Aberdour Road Active Travel Corridor

Engagement Report

On behalf of **Fife Council**

Project Ref: 332611069 | Rev: 1.5 | Date: May 2024

Figure 4-1 First Concept Design Iteration

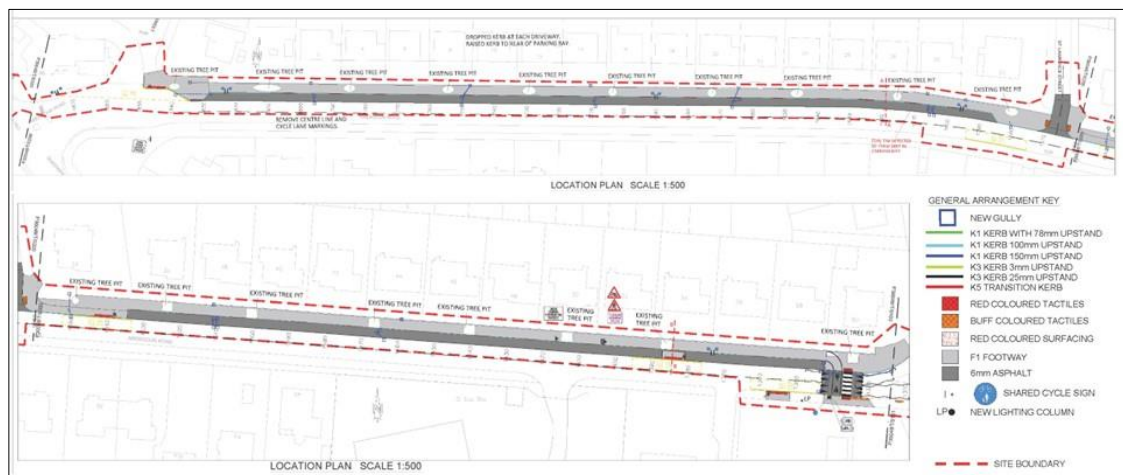
- 4.2.1 The western section of the ARATC goes through a residential area characterised by detached or semidetached houses, most of which have private driveways branching off Aberdour Road. The project area includes mature trees along the footways on each side of the carriageway. On the south side, the footpath is elevated from the carriageway and separated by a grass verge.
- 4.2.2 The Council produced initial concepts which included a shared-use footpath on the north side of the carriageway, as shown in **Figure 4-1** below.

Figure 4-4 Fourth Concept Design Iteration

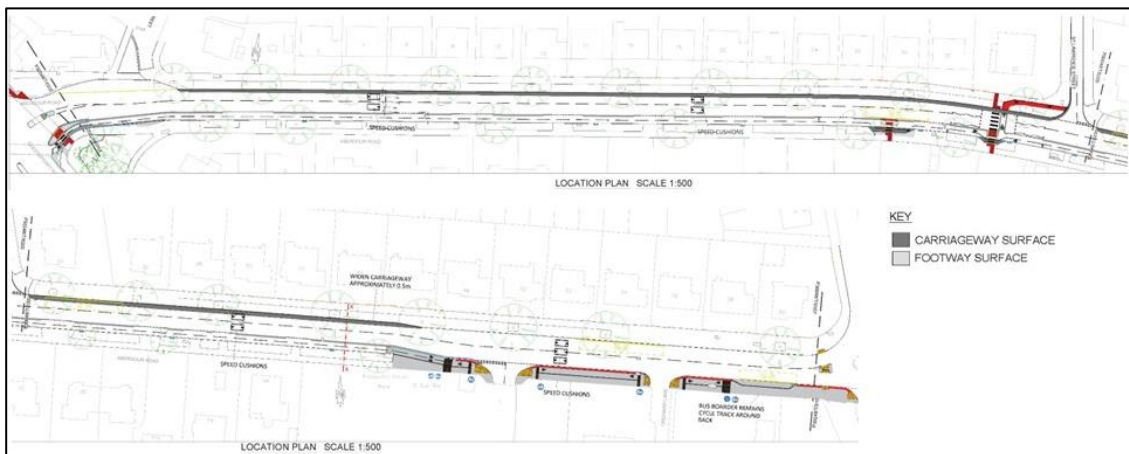
- 4.5.1 A fourth variation of the concept design adds speed cushions along the carriageway, an additional controlled crossing and an improved advisory crossing, following feedback about current speed and volumes of traffic and lack of crossing opportunities, particularly for those with disabilities. This latest version of the design, as shown in **Figure 4-4** below was the subject of this consultation exercise. The Council have engaged residents on each iteration of the design to date.
